Site Development Exemption Request

SIX-07-0032

Project Name: BULKHEAD REPAIR

Repair/Replacement of existing bulkhead to prevent further erosion.

TREE AND TOPOGRAPHIC SURVEY

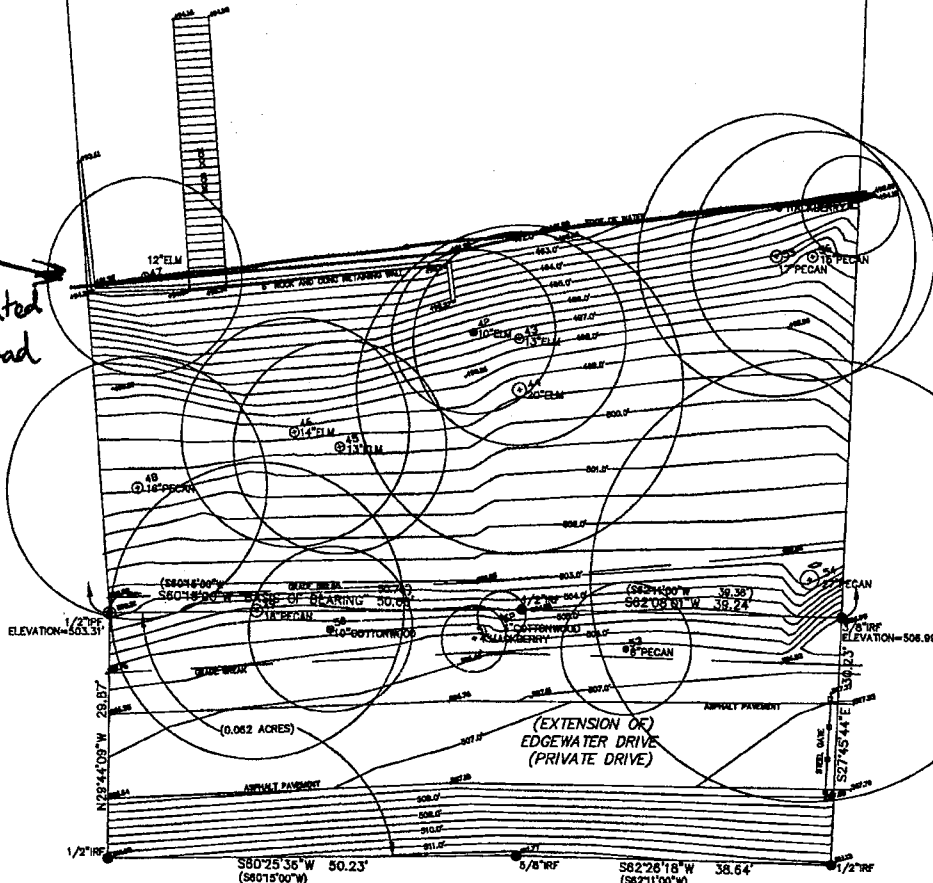
Replace Dilapidated Bulkhead

Proposed bulkhead profile for 2700 Edgewater Drive

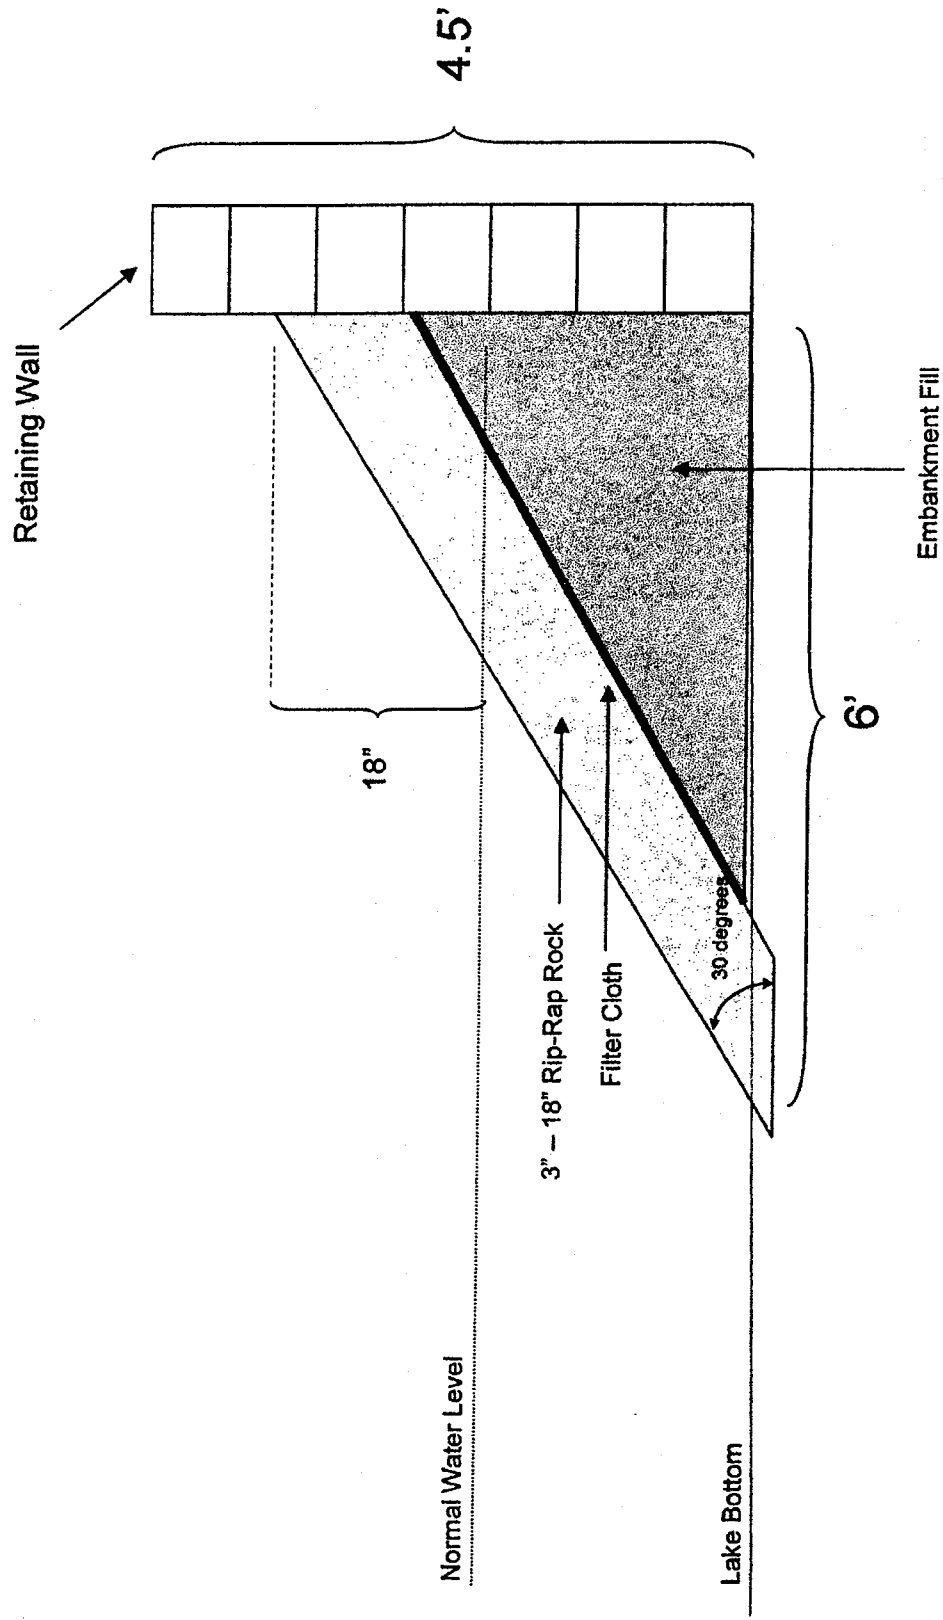
Project Name: Bulkhead Repair		Case Number: SPX-07-0032	Applicant Name: Nathan Chelstrom
<input checked="" type="checkbox"/> If Required	Reviewer: [Signature]	Date: 1-12-07	Comments: <input type="checkbox"/> SPOC*
<input checked="" type="checkbox"/> Site Plan	From the attached photos it appears that this wall is beyond repair and will require full replacement. A site plan will be necessary for this project.		
<input type="checkbox"/> Transport	N/A	<input type="checkbox"/> SPOC*	
<input type="checkbox"/> Engineer	N/A	<input type="checkbox"/> SPOC*	
<input checked="" type="checkbox"/> Environ.	Beth Lambert	1/12/07	<input type="checkbox"/> SPOC*
Provide a site plan. The bulkhead is beyond the point of repair.			
<input type="checkbox"/> AFD			
<input type="checkbox"/> AWU	N/A		
<input type="checkbox"/> Plumbing	N/A
